ASCENT LOGISTICS CENTRE, ALEXANDRIA SSD-32489140

Submissions Report

Prepared for
CHARTER HALL HOLDINGS PTY LIMITED
15 July 2022

Figure 1 Bourke Road setback

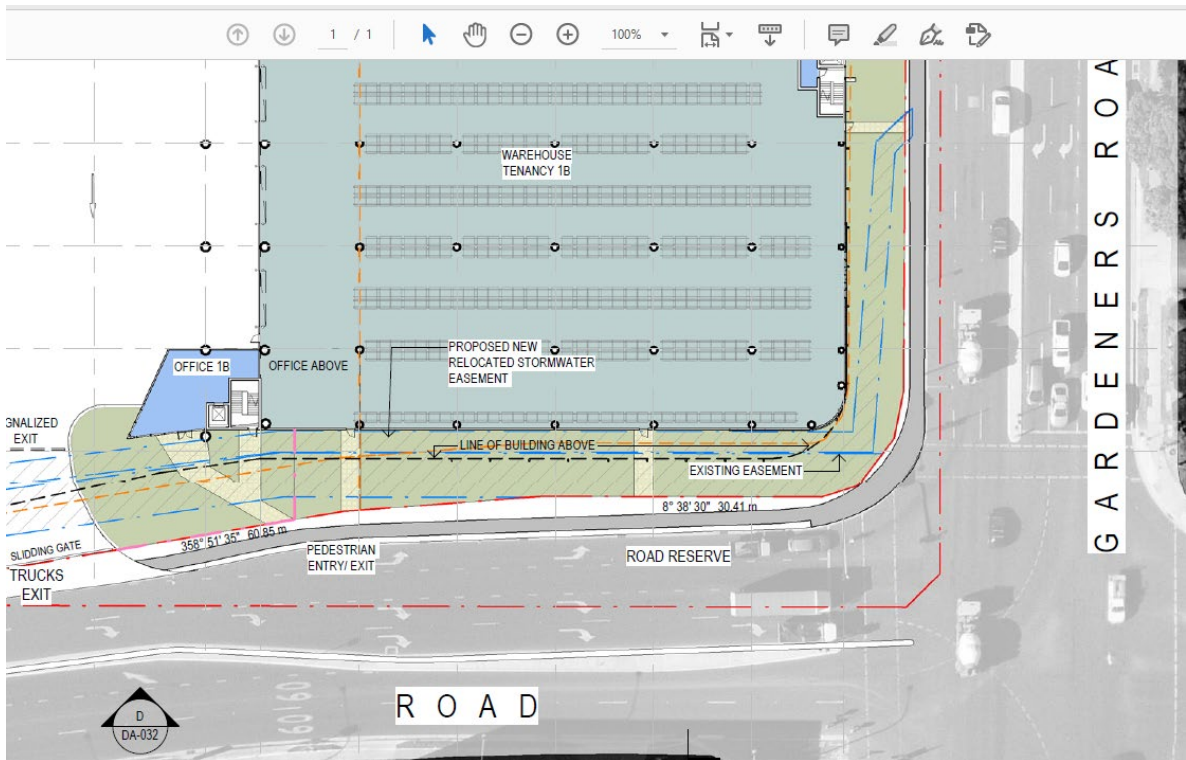
<p>Furthermore, fencing is not permitted along street frontages. The proposal, however, includes a 2.1m high fixed boundary fence proposed on the southern part of the Bourke Street frontage.</p>	<p>Fencing to the street frontage is proposed only for a minor portion of the Bourke Road boundary either side of the vehicular access driveway. This is for safety and security purposes. The majority of the landscape setbacks are open to the street.</p>
<p>4.1.2. Urban design</p>	
<p>The proposed building does not present a high-quality frontage and does not comply with the building envelope and 6m setback to Bourke Road as required by the SDCP.</p>	<p>As set out in Section 3, the proposed façade design has been refined to simplify the articulation of the façade and ensure a high-quality frontage is proposed including the proposed landscape setbacks.</p> <p>A 6m setback to Bourke Road is proposed at ground level. The minimal variation to the 6m setback requirement to Bourke Road at upper</p>

The City notes the modelling of the facade increases the visual dominance of the reduced setback and the intrusion of the building into the street setback may have an impact on planting.

Submission	Response
	<p>level over a small portion of the western façade is considered acceptable having regard to the objectives of the SDCP policy.</p> <p>In addition, as shown in Figure 1 below, the existing footpath to Bourke Road provides a landscaping area (shown in white) between the eastern edge of the footpath and the site boundary. This provides for a further setback of the proposed development from views from the public domain.</p>

It is also worth noting that the ground plane has an increased landscape setback where this

Submission	Response
	<p>incursion exists and the landscaping in this area has been designed with context and location understood.</p> <p>The proposed form has been used and balanced with the design of the building and its materiality to create a visually appealing interface to the streetscape and public domain. Overall, the building's design is considerate of its presence on the corner of two road frontages</p>
<p>A 3m landscape setback is required along Gardeners Road</p>	<p>A 6m landscape setback is provided to Gardeners Road.</p>
<p>The proposed setback along the northern frontage of the site, along the adjoining private driveway, of 4m does not comply with the 6m requirement as set out in Section 5.8.2.2. of the Sydney Development Control Plan (SDCP) 2012.</p>	<p>The DCP setback provision does not apply to the private driveway as demonstrated through the recently constructed data centres at 200 Bourke Road and 506-518 Gardeners Road, with both these DAs determined by the City of Sydney. The SEE for the Stage 2 data centre DA confirmed the east-west road was no longer required by Council in accordance with pre-lodgement advice in association with the original Concept DA.</p>
